NABCO ENTRANCES TECHNICAL BULLETIN

**Change to the Location of Rocker Switches on 1175 Sliding Doors
(National Accounts only)**

Bulletin Number: **48**

Interior Elevation (full open slider shown)

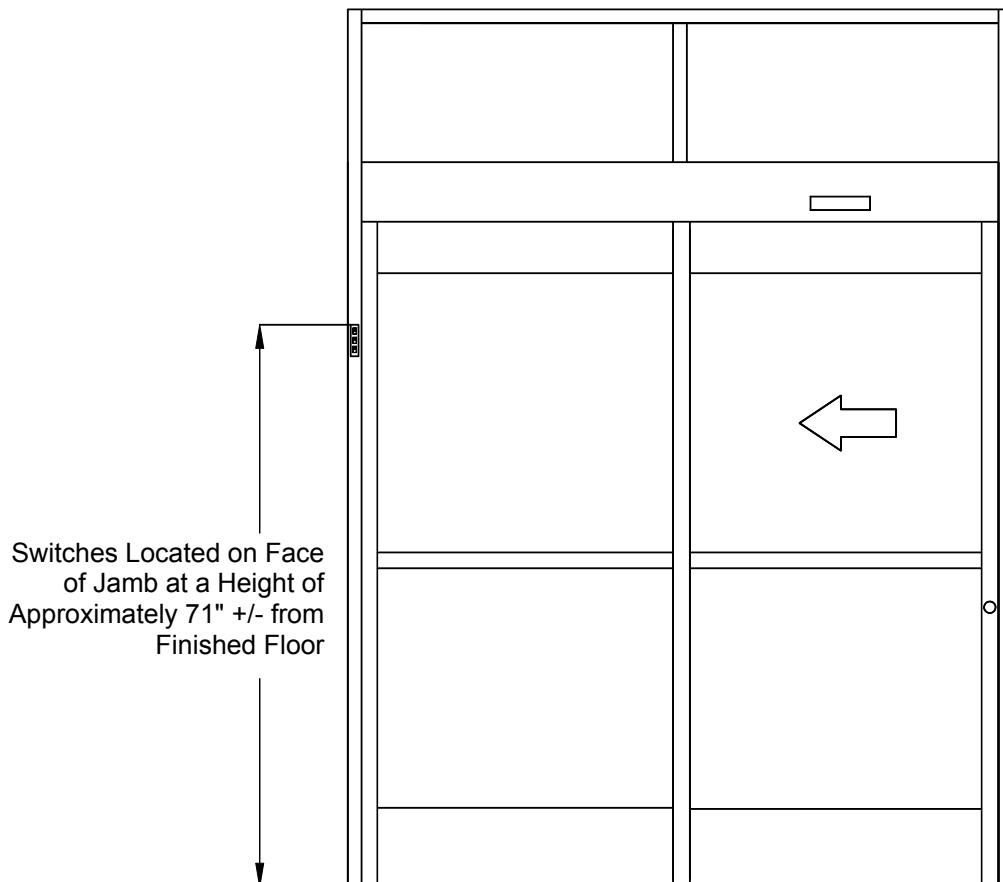
Effective immediately, all GT-1175 Sliding Door Systems that are supplied on Nabco National Account projects will have the rocker switch located on the face of the jamb tube as shown below. The rocker switch will not be located on the sidelite panel as is currently done on standard sliders.

Switches will be installed on the inside jamb face on the same side of the frame that the control and operator is located. On full open sliders this is typically the left side (see below) and on fixed sidelite sliders this is typically the right side as viewed from the interior.

We expect this change to also facilitate installation of the sidelites as well as eliminate damage to rocker switch wiring between the header and sidelite.
